**DATE:** January 25, 2021  
**TO:** Blue Bird Owners  
**Subject:** R20AW – Drag Link Castle Nut Torque Confirmation

**NHTSA Recall Number: 20V-356 School Bus**  
**NHTSA Recall Number: 20V-357 Non-School Bus**

## R20AW Drag Link Castle Nut Torque

Fig. 1

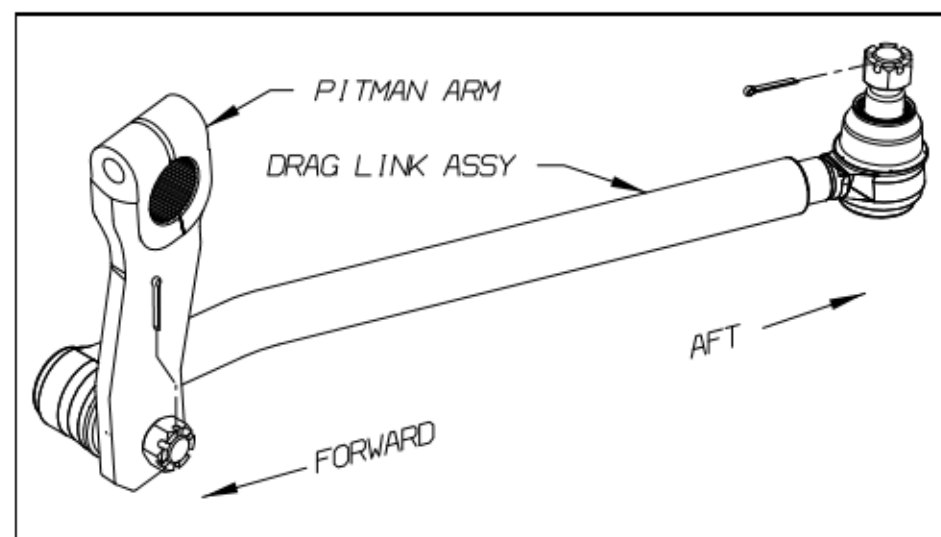
**Issue:** The castle nuts on both ends of the drag link assembly may not have been installed according to manufacturer's installation specifications.

1. Check the taper stud joint at both ends of the drag link to ensure the joint is tight. This can be completed by applying both vertical and horizontal pressure to the drag link. (Push and Pull) **No movement is allowed.**
2. If movement is found, the drag link will need to be removed for inspection of the machined surfaces and stud threads. No wear or oblong hole is allowed.
3. Replace any components that are found to be worn or damaged.
4. If the taper joints are tight move to step (1) of the instructions.

1. Park bus on a level surface, apply parking brake, switch engine off, remove ignition key and chock wheels.
2. Remove cotter pin from ball stud on forward (pitman arm) end of drag link. (Fig. 1)
3. Torque castle nut on drag link ball stud to 120 ft-lbs.
4. Remove cotter pin from ball stud on aft (steer arm) end of drag link. (Fig. 1)
5. Torque castle nut on drag link ball stud to 120 ft-lbs.
6. Install cotter pins.
7. If castle nut slot for cotter pin does not line up with through hole in each ball stud, tighten castle nut until next slot aligns with through hole. Install cotter pin and bend-over pin tails. **WARNING: Do NOT loosen castle nut to line up slot with through hole in ball stud. Always tighten castle nut to align slot with through hole.**
